**FINAL DRAINAGE REPORT
FOR
MC CLINTOCK STATION LOT A
(VOLLMER ROAD RV STORAGE)**

**May 2023
Project No. 25251.00**

PCD File No. PPR-2245

EXISTING DRAINAGE MAP
VOLLMER RV STORAGE
JOB NO. 25251.00
05/10/2023
SHEET 1 OF 1

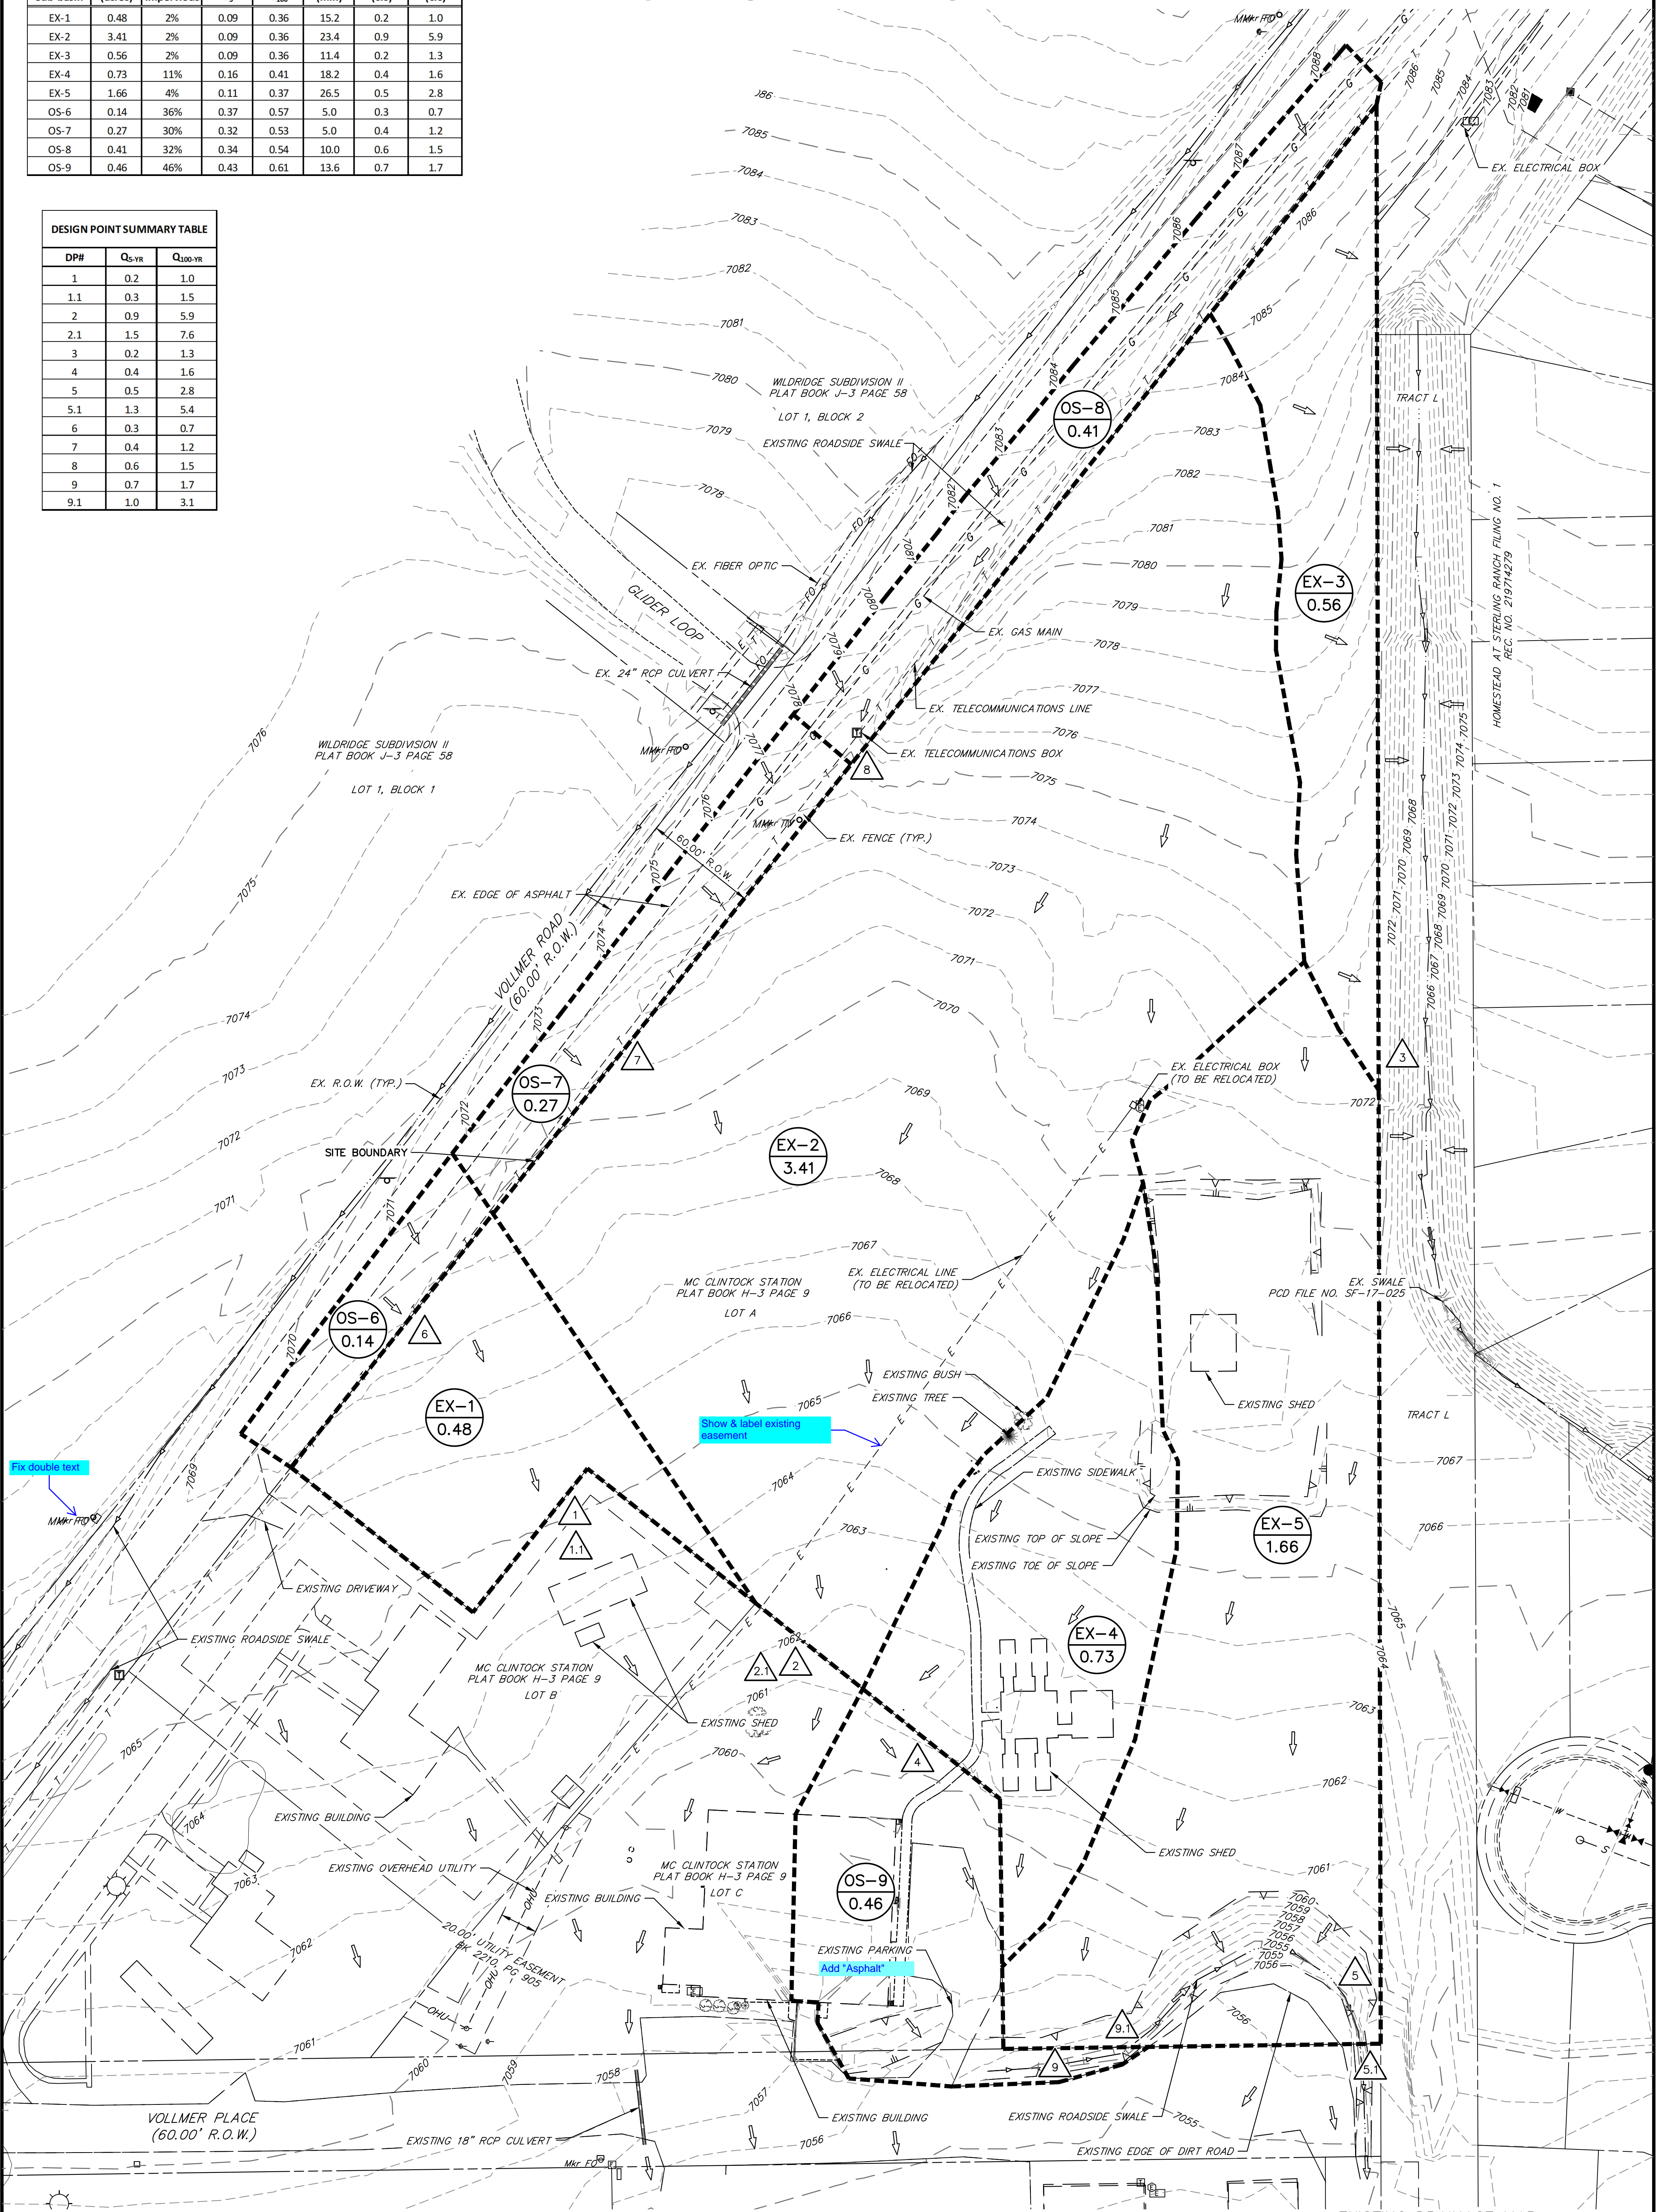
Show & label existing easement

Add "Asphalt"

PROPOSED DRAINAGE MAP
VOLLMER RV STORAGE
JOB NO. 25251.00
05/01/2023
SHEET 1 OF 1

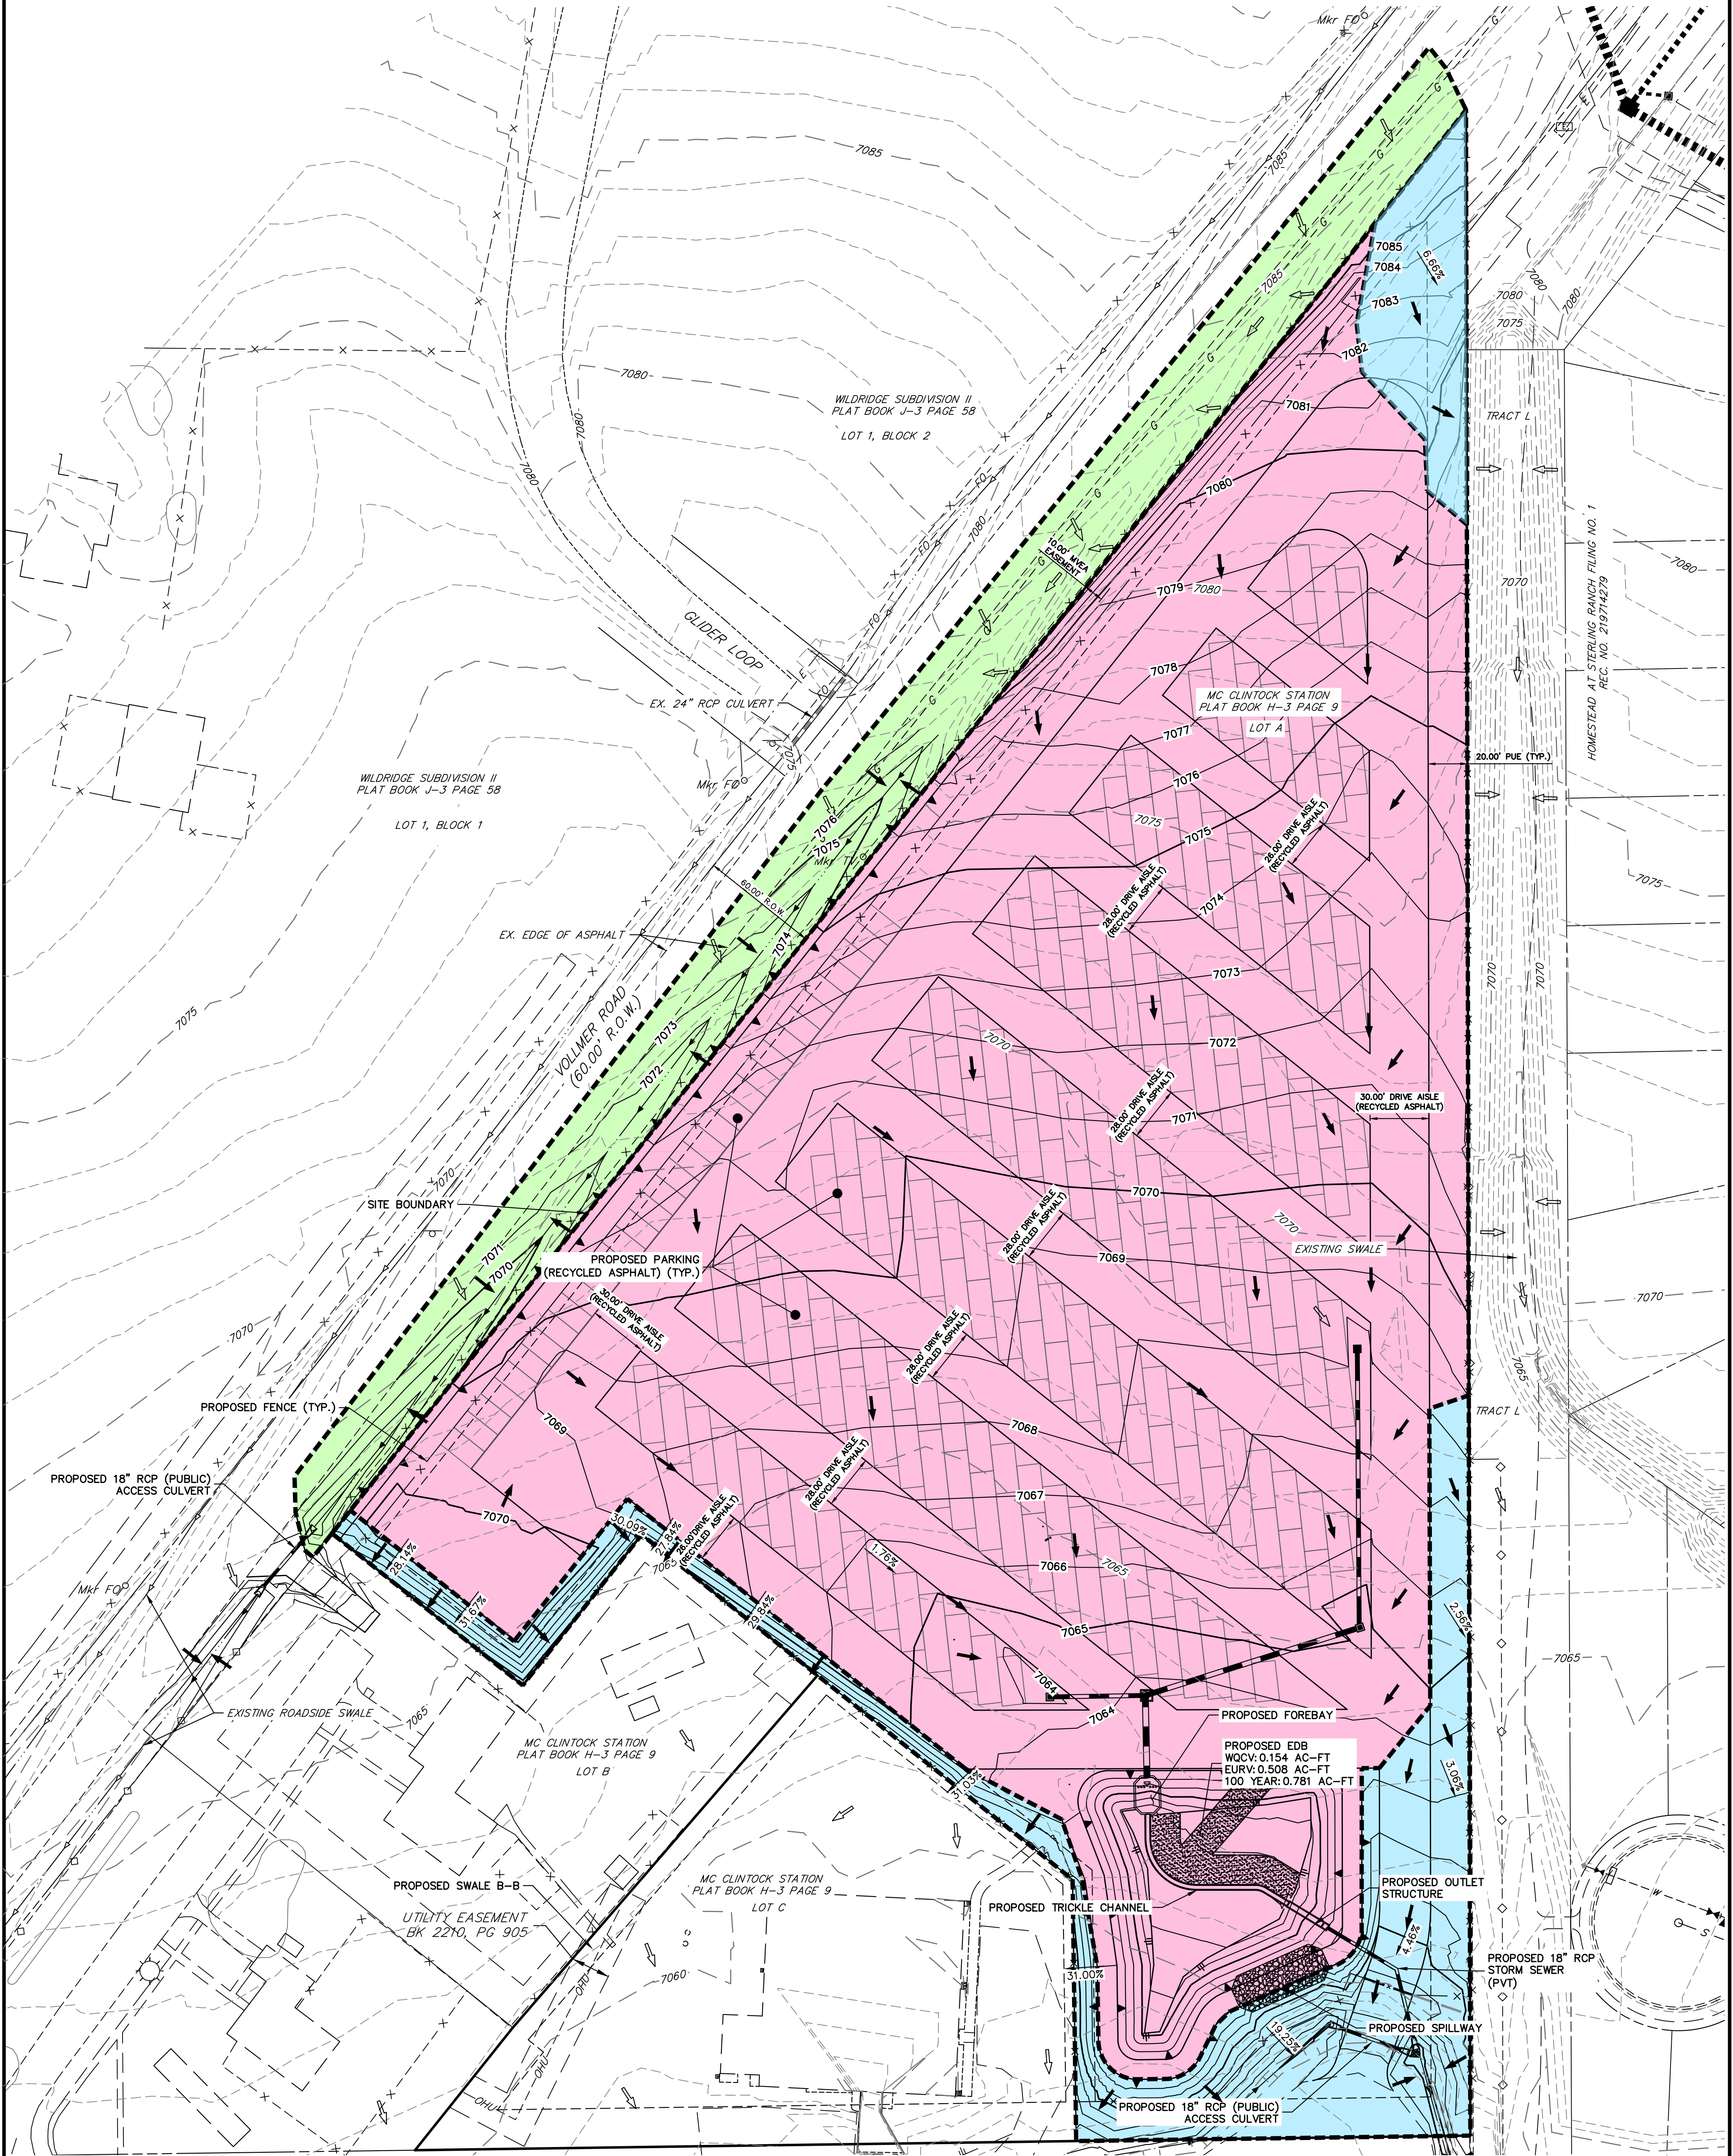
Include flow paths (Time of concentration path) for each basin as labeled on previous drainage map version.

Drainage report referenced landscape areas where flows would be routed through. Show and label these areas on map.
